MEMO

Subject: Application Review: PA-25-0004 Williams Elm Drive Partition

Date: July 22, 2025

Per the City of La Pine's request, Anderson Perry & Associates, Inc., has reviewed the tentative plan of a three-lot partition of Lot 11 Block 3, Gagle Subdivision, Plat No. 4 on Tax Lot No. 211036BA01100 for the potential impacts to public utilities and roadways. The public improvements shown on the tentative plan were reviewed using the City's 2016 Standards and Specifications Design Standards (Design Standards). The review comments are listed below by public facility.

SHEET
C57

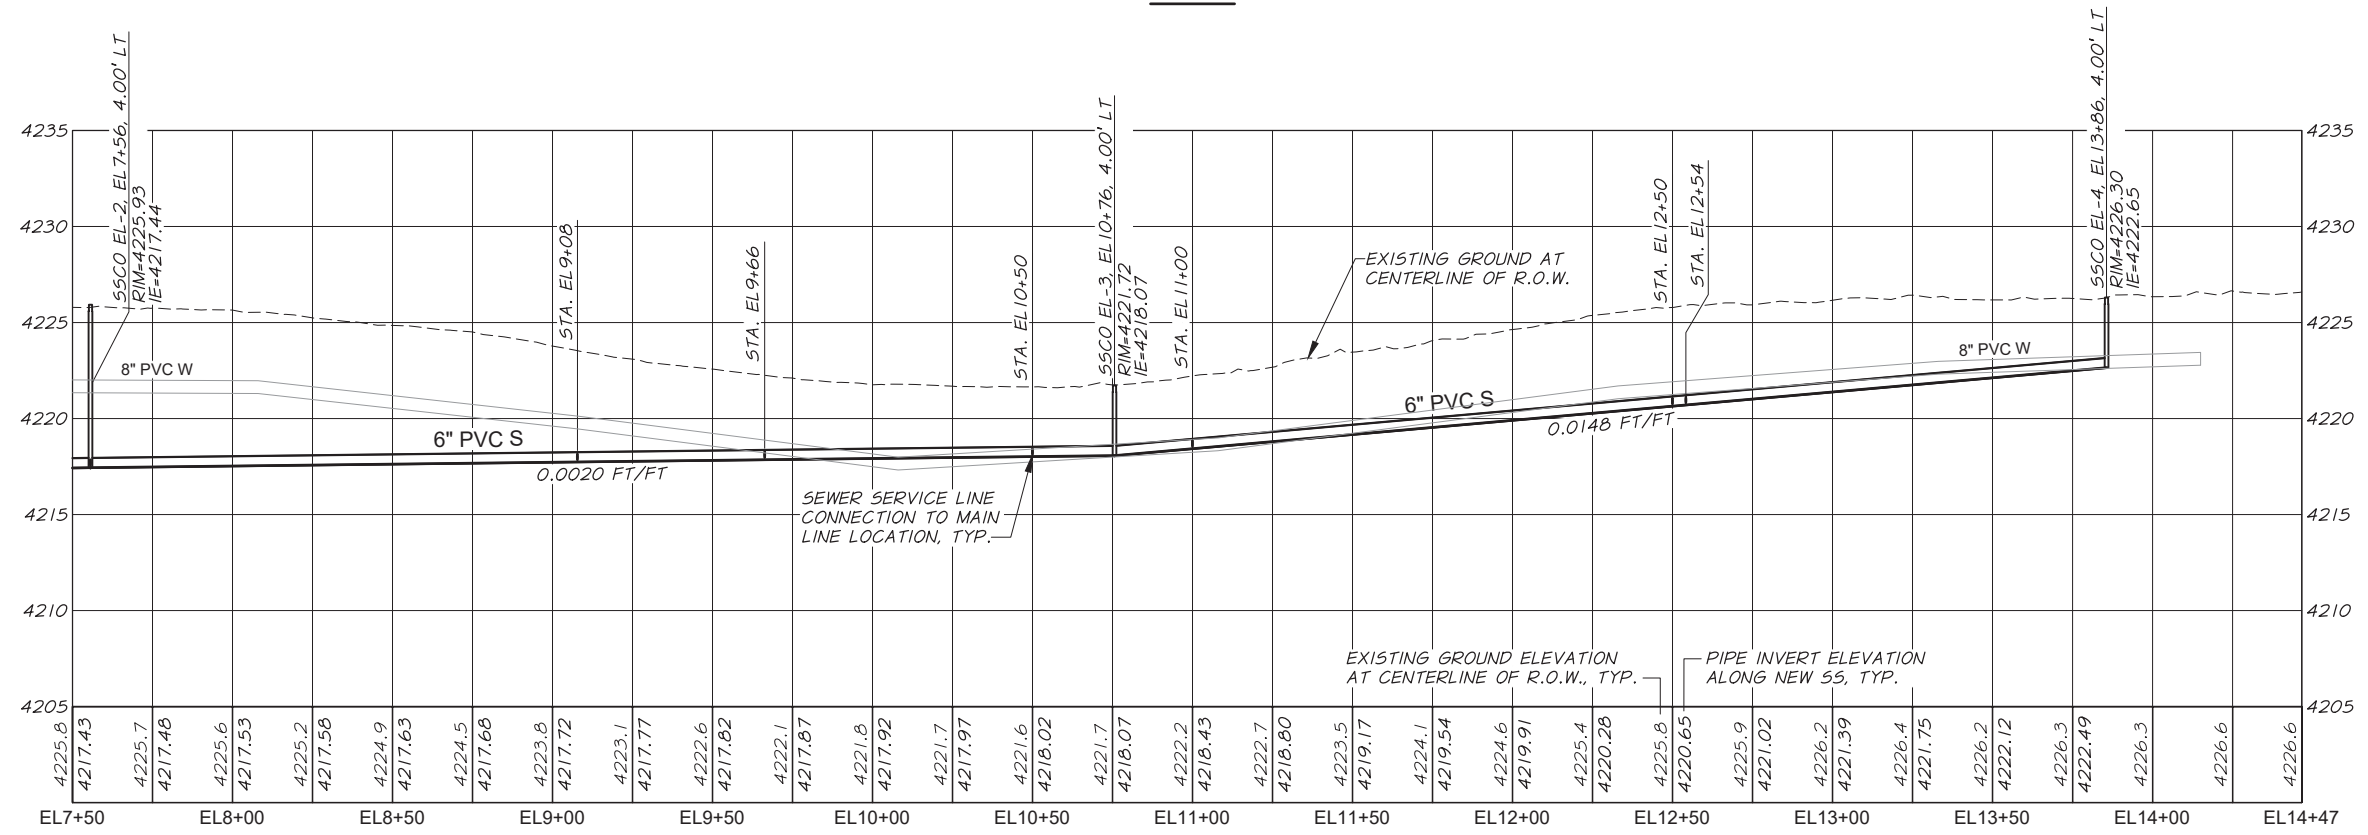
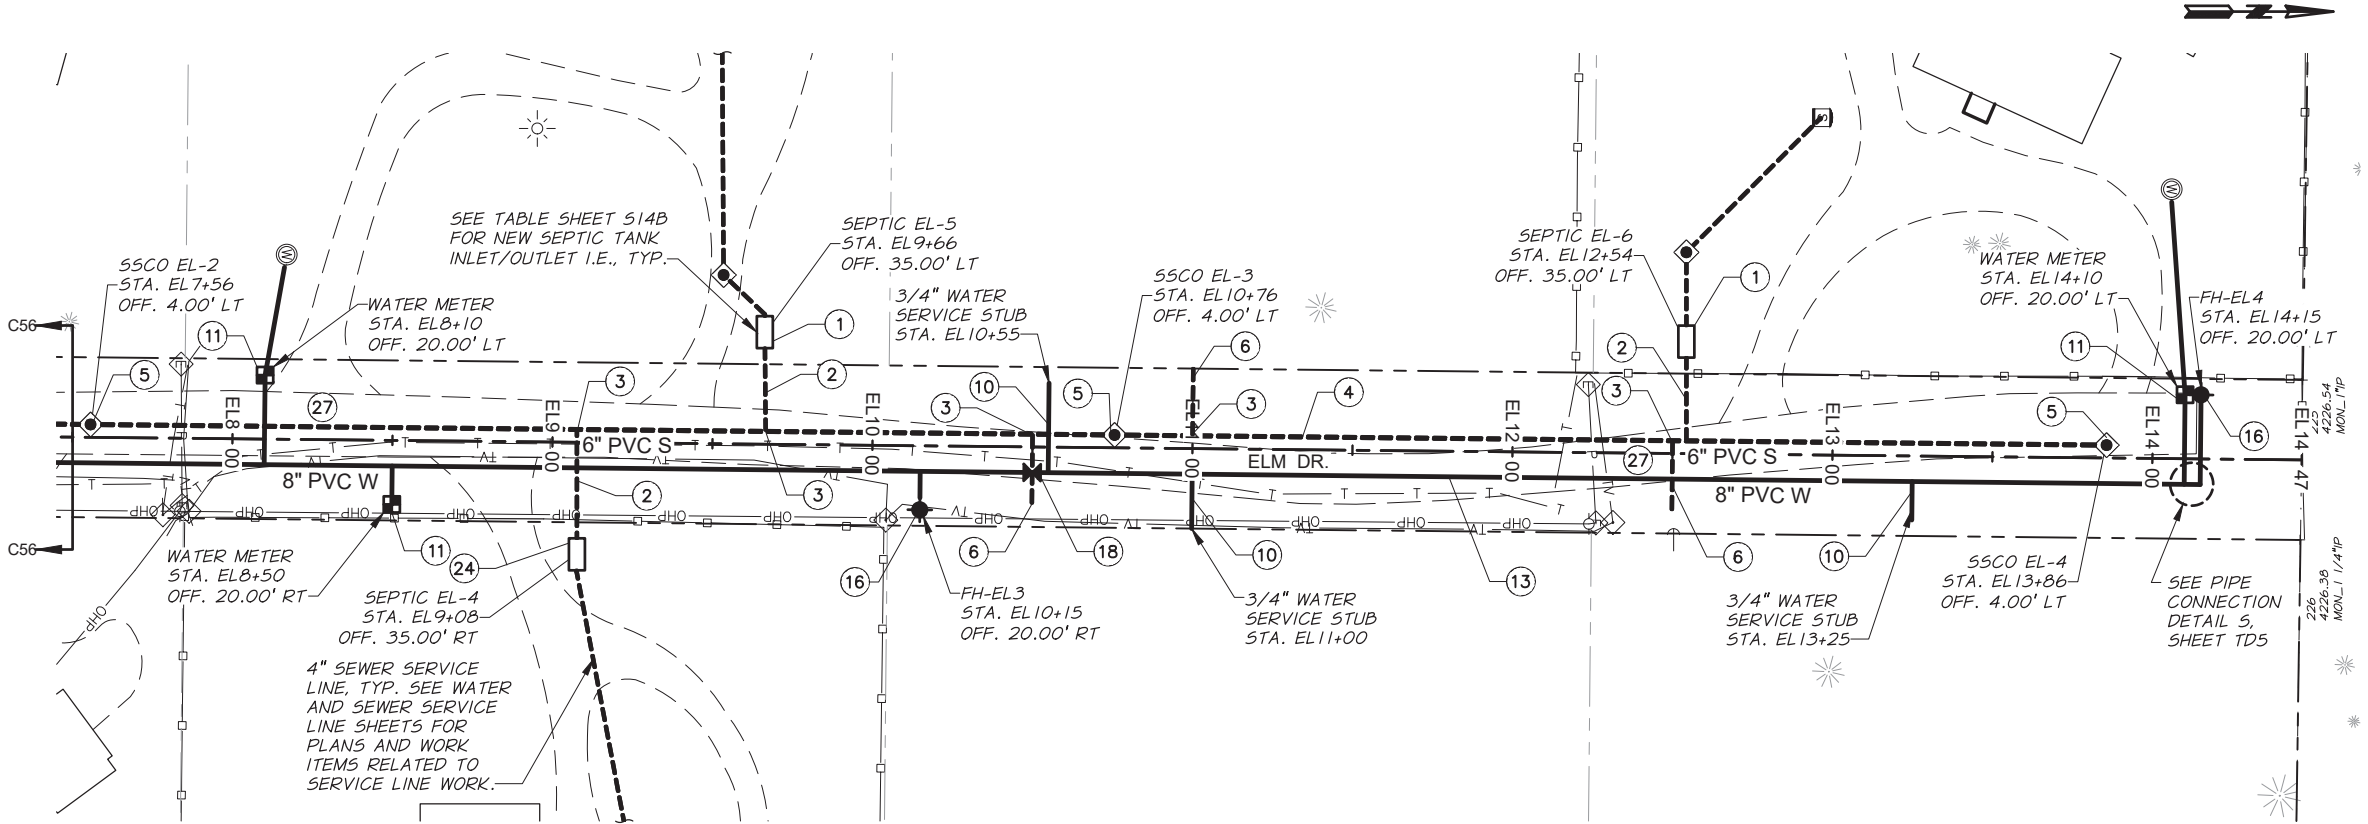
Sheet C57 from the City's Water and Wastewater Improvements - Schedule C - Cagle and Glenwood Acres project is attached as a reference for water and sewer service locations.
